Access Compliance Report

Public Rights-of-Way

(Curb Ramps)

Intersection ID: 3673	Main Street: KEENELAND_LN	Cross Street: DENALI_LN	Location:	SE
ADA ID: C554B63A6180	Ramp Type: Perp	Initial Pass/Fail: Fail	Overall Compliance: No	Severity Score: 30
Codes/Mitigation Info/Possible Solution		Field Measurements/Component Compliance

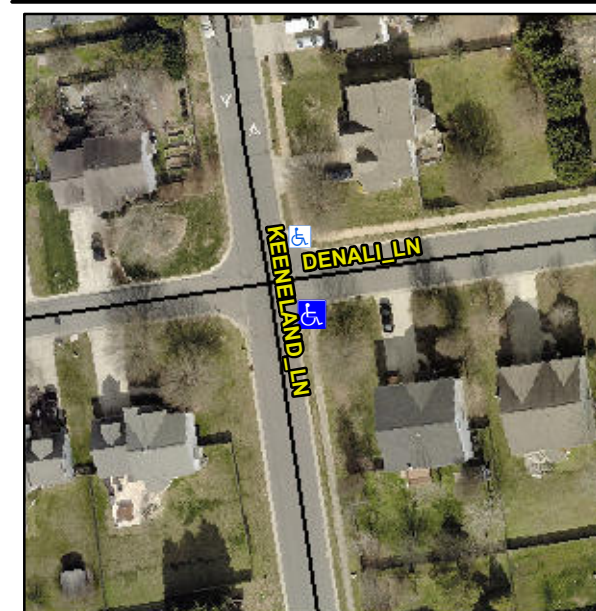
Not Found, R304.5.1, R304.5.3

Compliance	Description	Data	Compliance	Description	Data
N/A	Ramp Length (in)	42.5	Yes	Ramp Slope (%)	5.7
No	Ramp Width (in)	35.0	No	Ramp XSlope (%)	5.4
N/A	Flare Type LT	N/A	N/A	Flare Type RT	N/A
N/A	Flare Slope LT (%)	N/A	N/A	Flare Slope RT (%)	N/A
N/A	Flare Traversable LT?	N/A	N/A	Flare Traversable RT?	N/A
N/A	Landing Length (in)	N/A	N/A	DWS Provided?	N/A
N/A	Landing Width (in)	N/A	N/A	DWS Contrast?	N/A
N/A	Landing Slope (%)	N/A	N/A	DWS Length (in)	N/A
N/A	Landing X Slope (%)	N/A	N/A	DWS Full Width?	N/A
N/A	Landing Curb? (Y/N)	N/A	N/A	DWS Offset (in)	N/A
N/A	Shared Landing?	N/A			
N/A	Gutter Ponding?	N/A	N/A	Gutter Slope (%)	N/A
N/A	Gutter Lip Ht (in)	N/A	N/A	Gutter X Slope (%)	N/A
N/A	Painted X Walk1?	No	N/A	Painted X Walk2?	N/A
	X Walk 1 Direction	To N		X Walk 2 Direction	N/A
N/A	X Walk 1 Width (in)	N/A	N/A	X Walk 2 Width (in)	N/A
	X Walk 1 Slope (%)	0.9		X Walk 2 Slope (%)	N/A
	X Walk 1 X Slope (%)	5.8		X Walk 2 X Slope (%)	N/A

Remove & Replace Entire Ramp.
